Permit # _____ City of Portland BUILDING PERMIT APPLICATION Fee 25.00 Zone 186 Map # D Lot# 10

RE: 49-51 Bolton St.

Your application to rebuild deck has been reviewed and a permit is herewith issued subject to the following requirements:

49-51 BOLTON ST

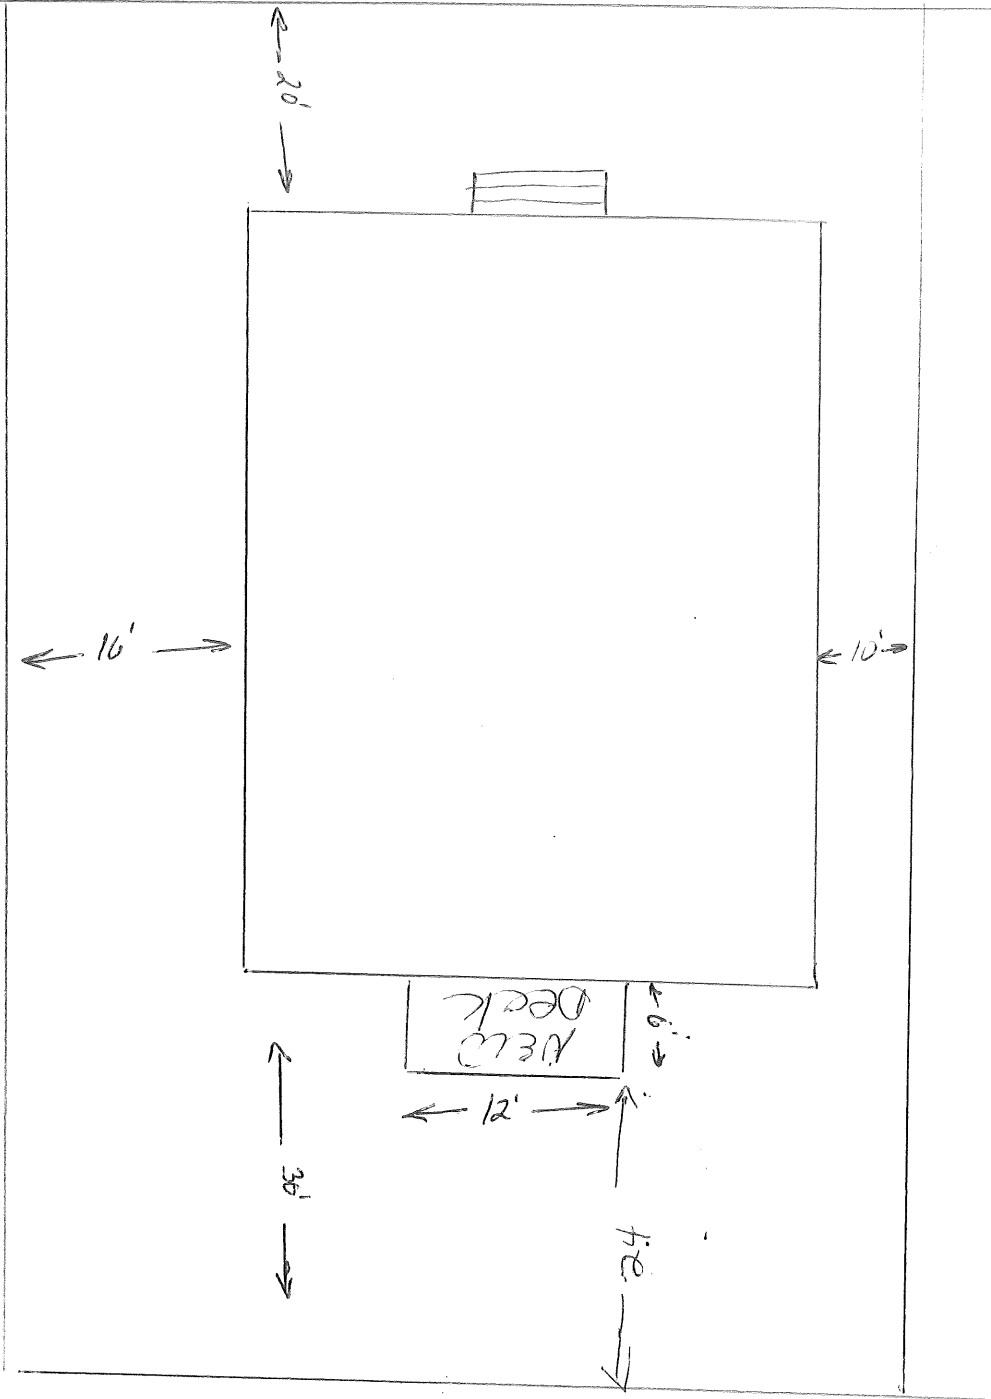
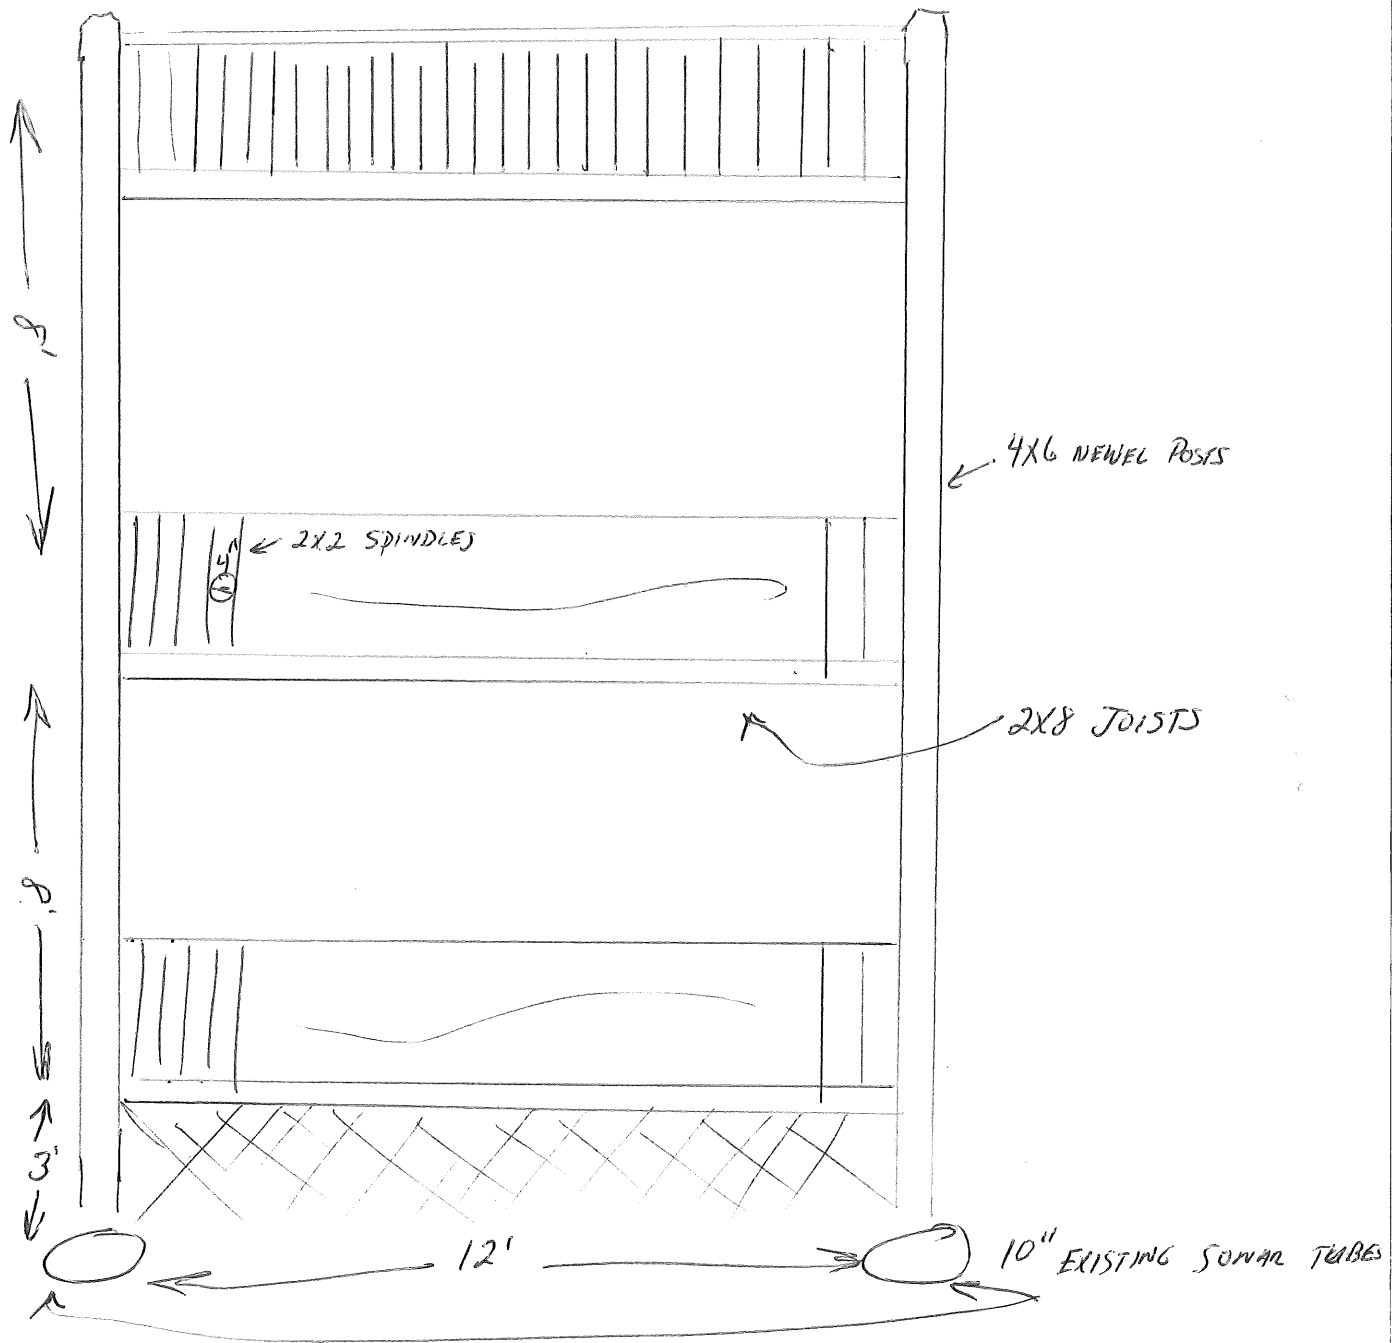
1. Guards and handrails shall comply with Section 5-2.2.4 of the Life Safety Code.
2. Stairs shall be in accordance with Section 5-2.2.2.1 of the Life Safety Code. (Maximum riser 7"-minimum tread 11")
3. Means of egress shall be illuminated.
